Lincoln Land Wind Project

Siting Application Review

Morgan County, Illinois

Prepared By:
Patrick Engineering Inc.

Figure 2. Illinois Pollution Control Board (IPCB) limits versus anticipated maximum sound power levels within each octave band.

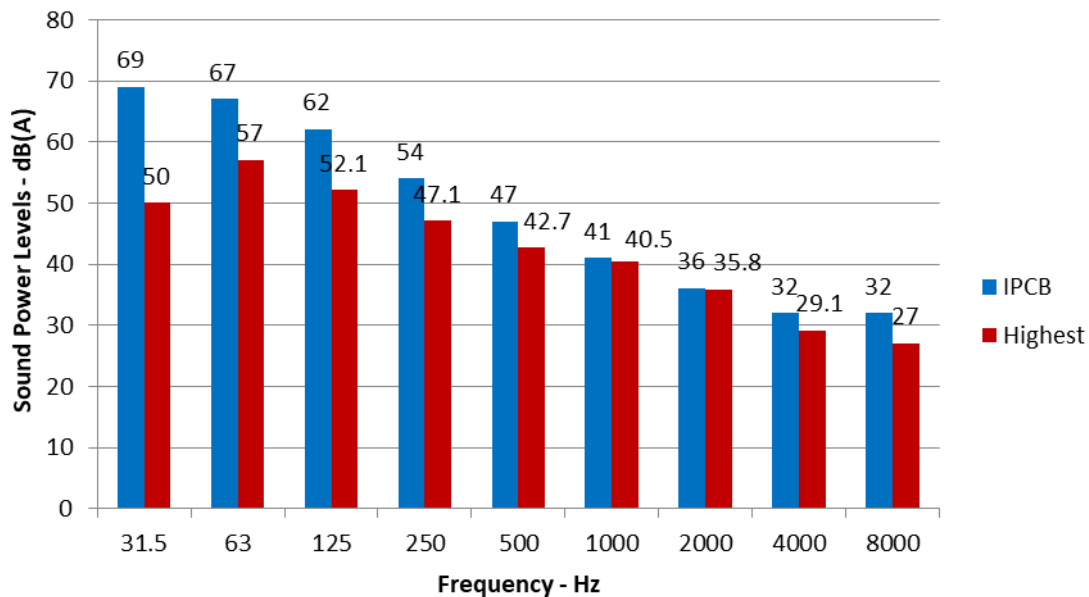
The application source and receptor data was reviewed for all locations, and a summary of the highest sound levels versus frequency band was created. The data was scanned across every sound emitting point source and across every band to determine the maximum predicted levels. This summary is plotted in Figure 2 and shows that all the predicted levels are lower than the regulation.

Figure 3. Validation of sound prediction models at Locations 14, 27, 192, 211

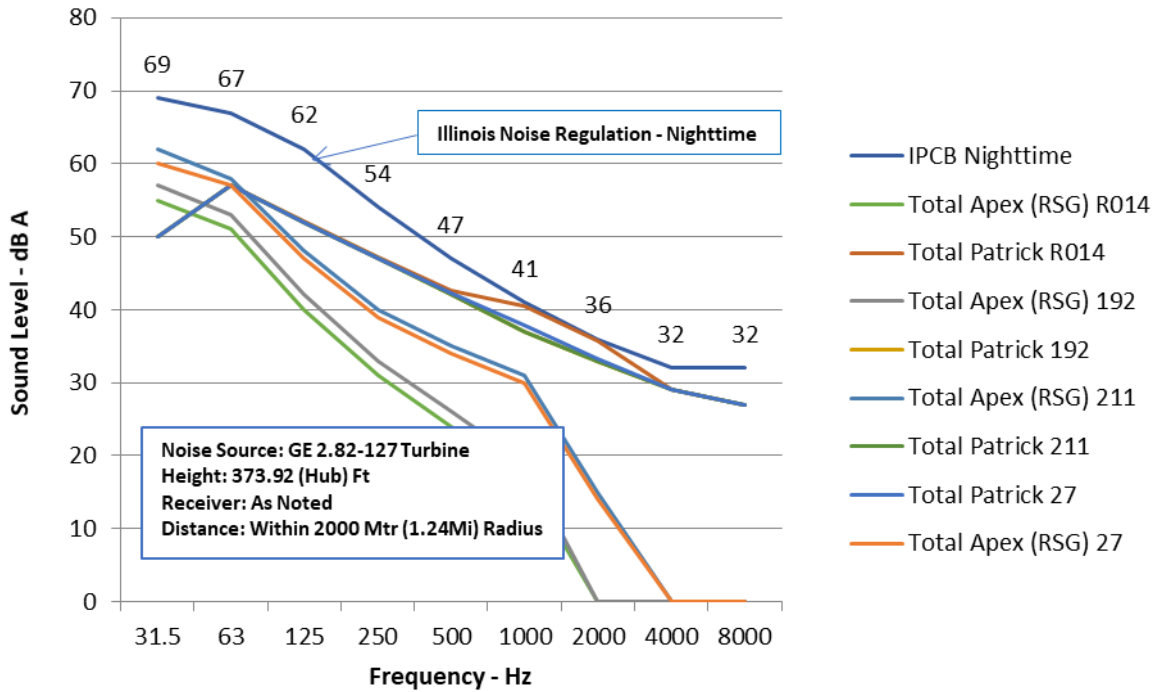
It can be seen immediately that all the levels predicted are below the IPCB regulation for these locations. The Patrick model did not include any NRO's (Noise Reduction Operations) other than the LNTE (Low Noise Trailing Edge) blades. The Patrick model includes the addition of the noise from the step up transformer at the base of the turbine tower as well as the standard noise levels attributed to nighttime ambient noise for rural (farmland) areas.

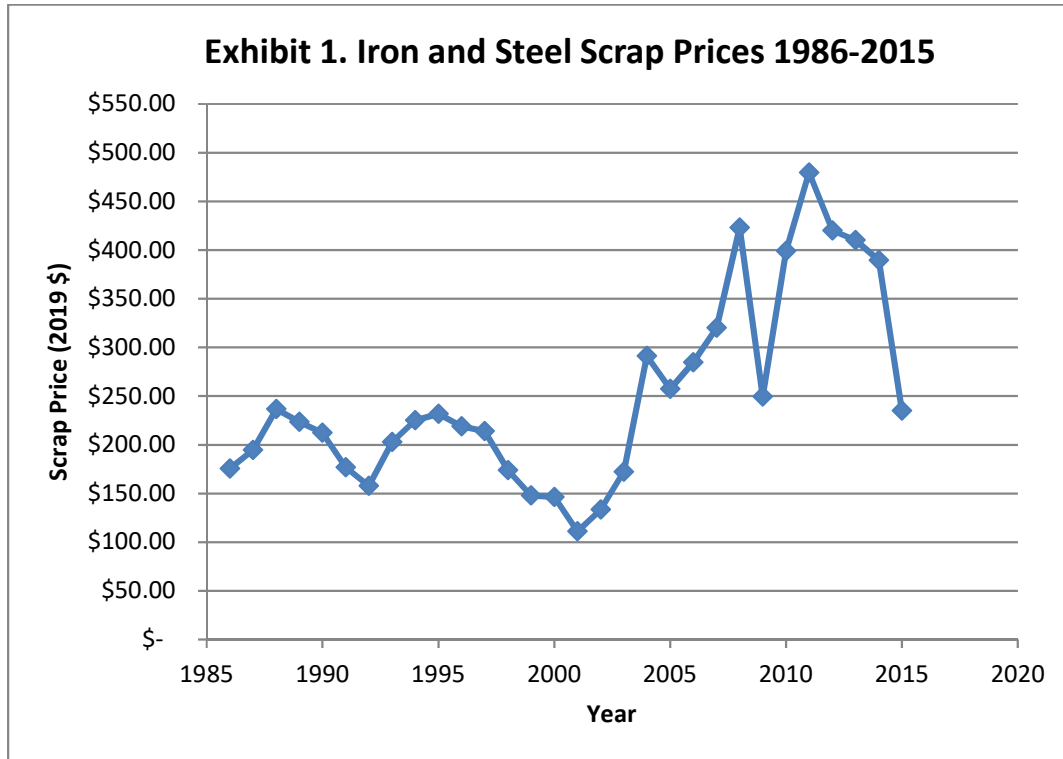
Patrick reviewed historical statistics from the US Geological Survey for iron and steel scrap prices for the years 1986 through 2015 (30 years of data), in order to compare Plan scrap prices to the long-term average price for scrap steel in the U.S.

For this 30-year period, the average price for scrap was approximately \$250/ton in 2019 dollars, which is similar to the value used in the Plan (\$240/ton). However, scrap prices during that time vary widely (see Exhibit 1) – prices range from just over \$100/ton to over \$400/ton.
